PUBLIC STORM DRAIN STANDARDS

Adopted by the Santa Rosa City Council

Date: 8/31/2023

| CHK: | | STD - 400 |

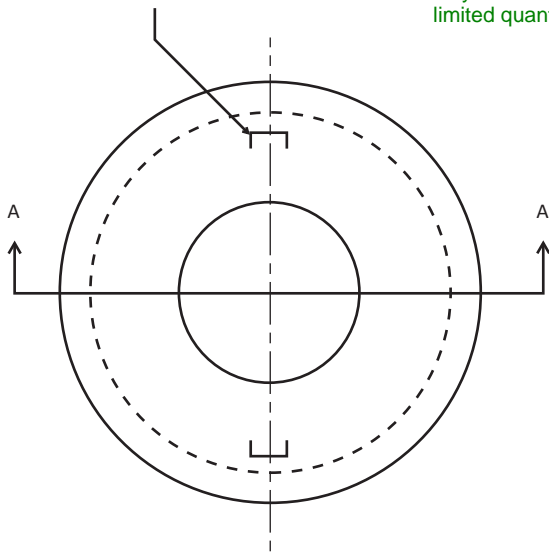
Labeling them City of Santa Rosa will add cost and create supply chain issues, because this will only be stocked by local manufacturers and in limited quantity.

STD - 402A

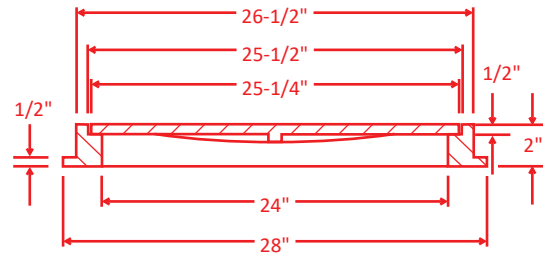
This top is for a different catch basin than the Type II

Need to add back the Section A-A for clarity.

CATCH BASIN COVER

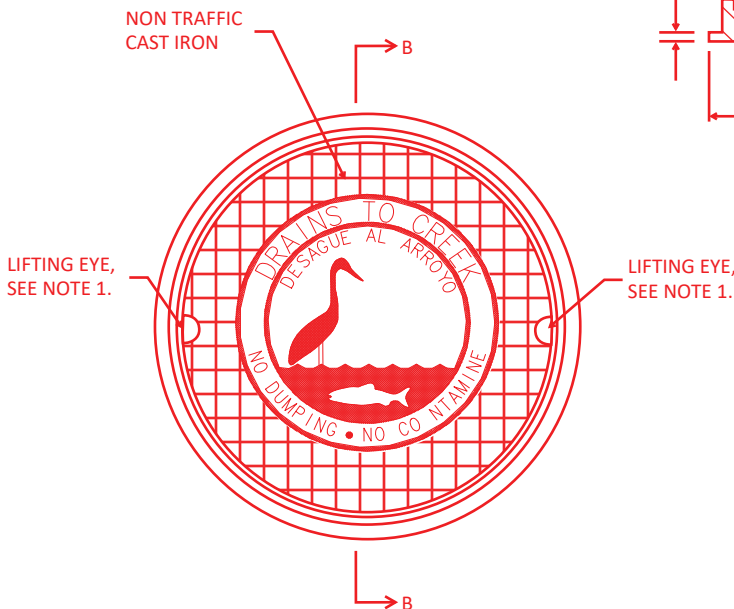
Make Sure graphics are commercially available. This Lid detail should probably be a separate detail and referenced in multiple standards.

SECTION A-A
(FROM STD-402B)

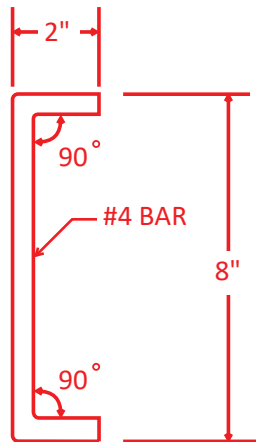
This section should really be a part of Std 402B

| CHK: | | STD - 402D |

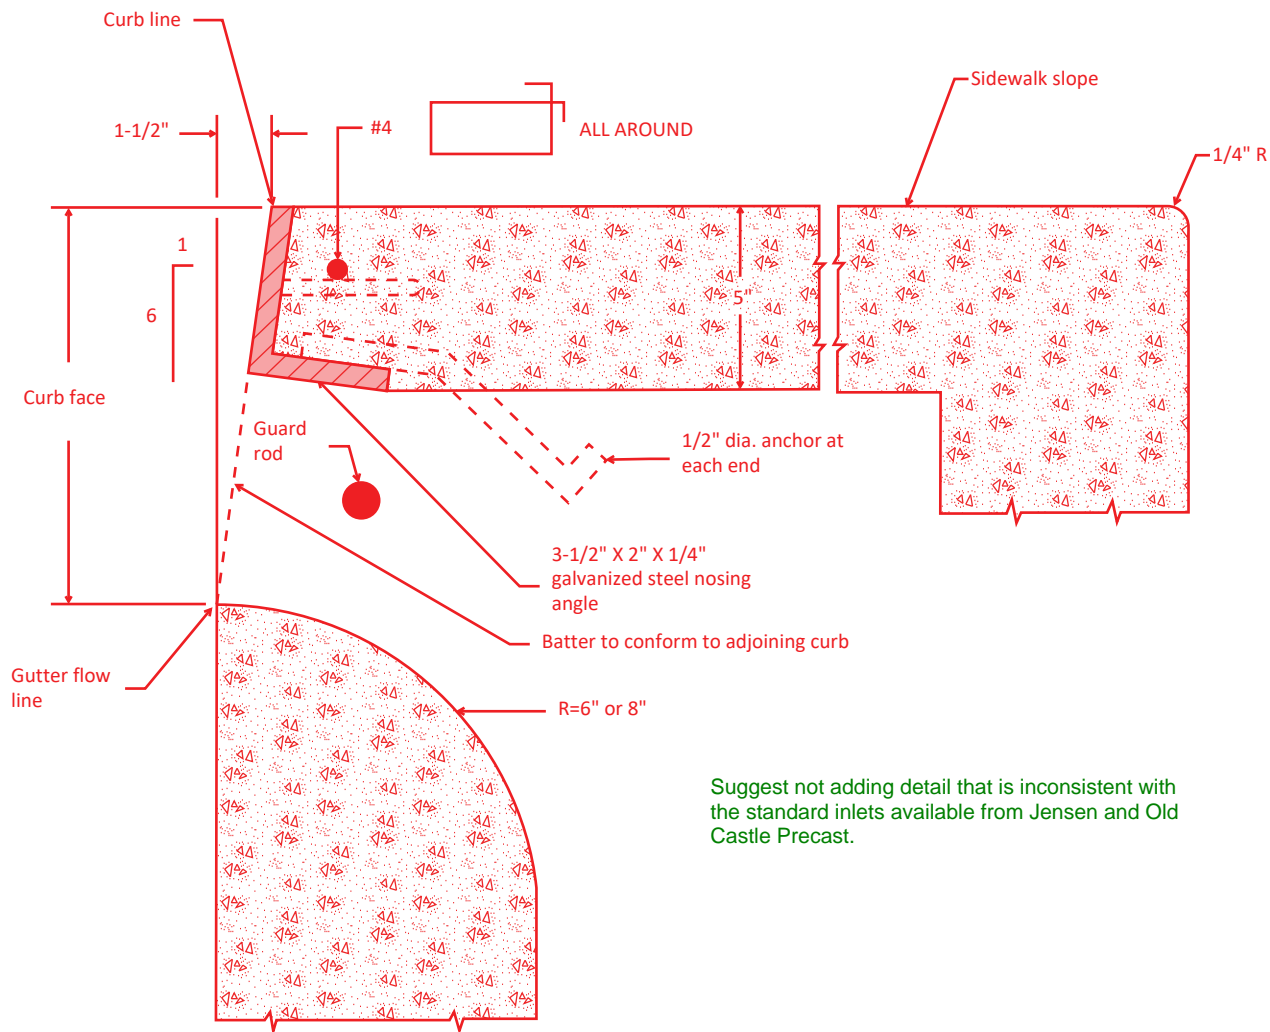
Suggest not adding detail that is inconsistent with the standard inlets available from Jensen and Old Castle Precast.

SECTION A-A

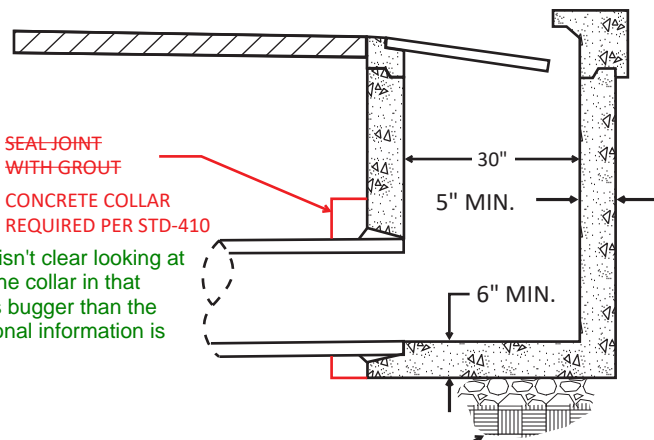
The intent isn't clear looking at Std 410. The collar in that standard is bigger than the CB. Additional information is needed.

STD - 413

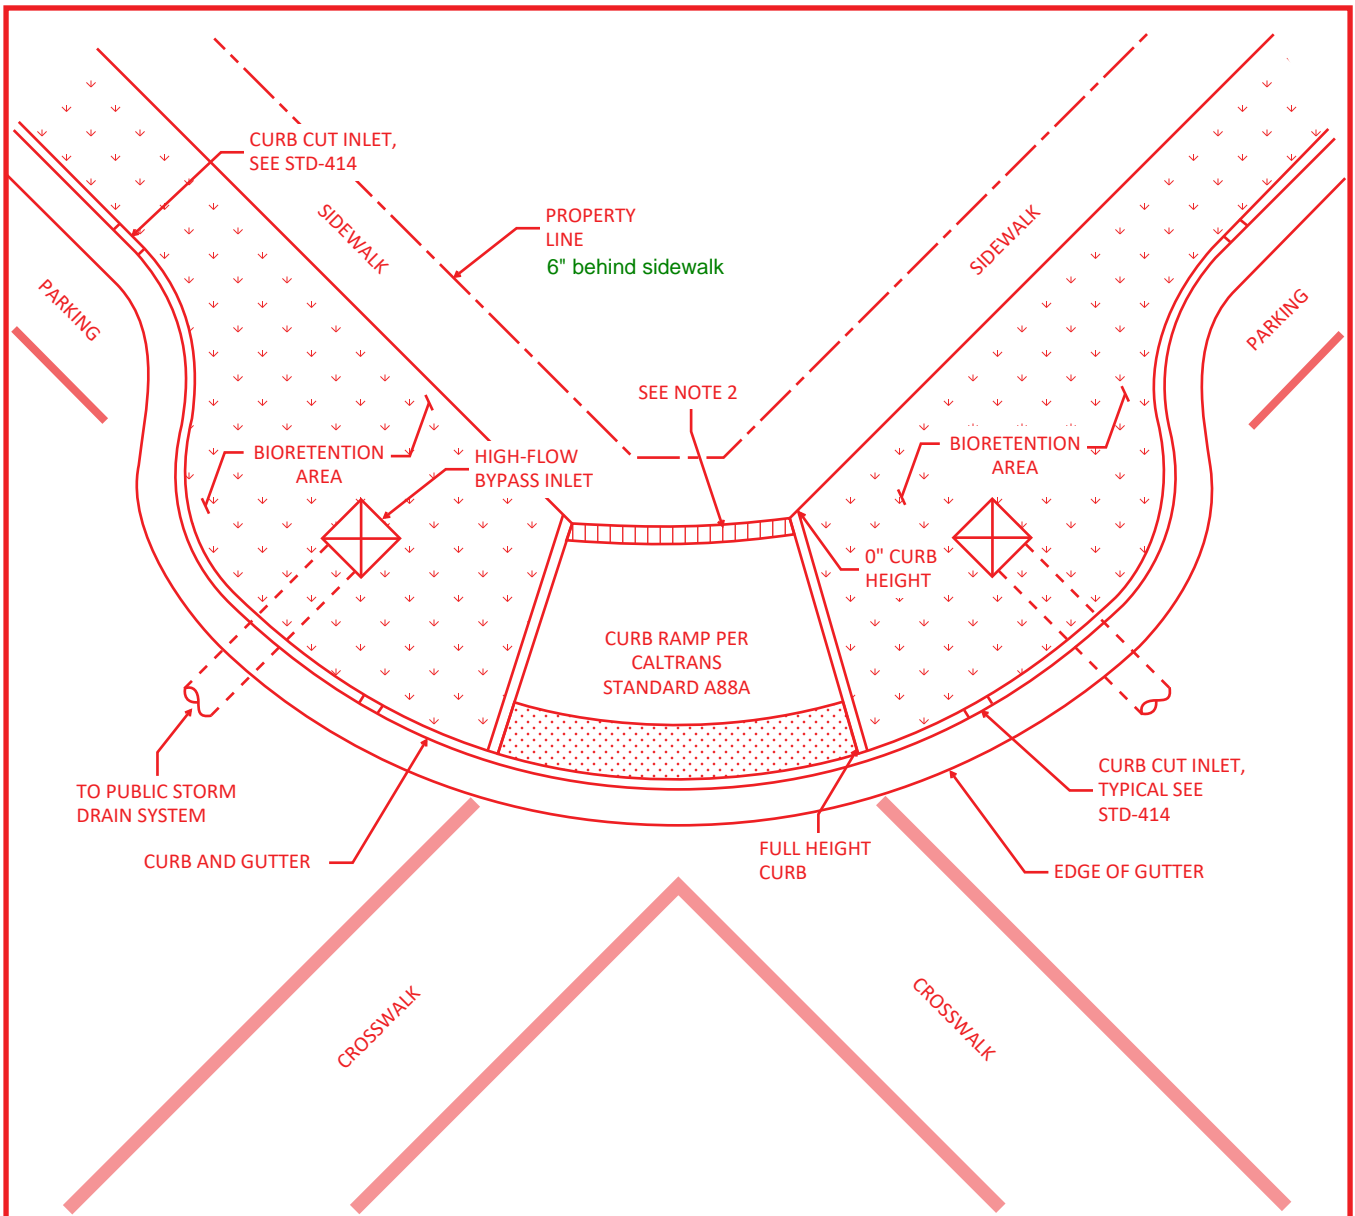
Not sure how crossing. This at the terminal bays. Mid Block require special

STD - 415

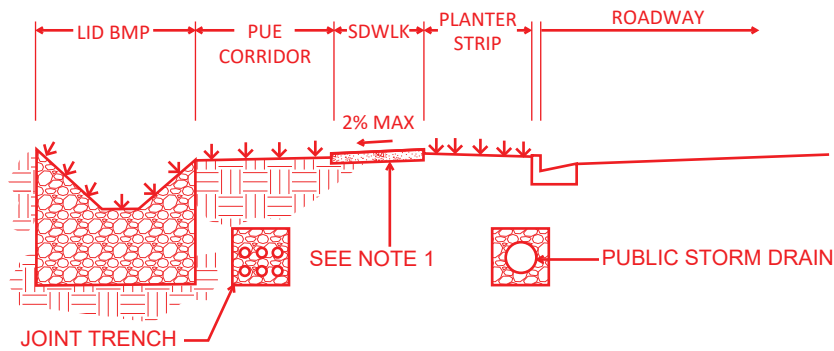
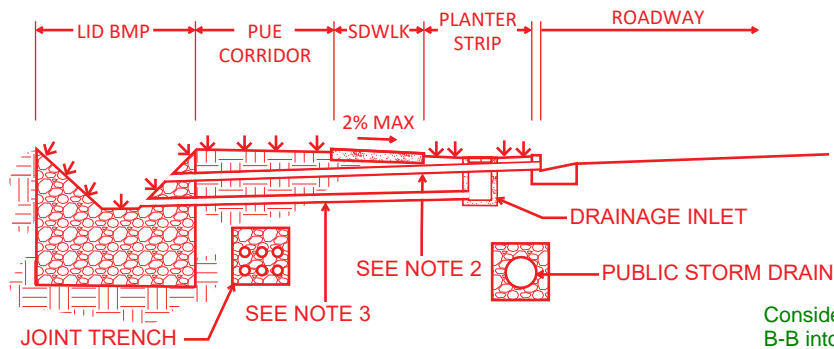
Consider breaking Sections A-A and B-B into 2 separate details.
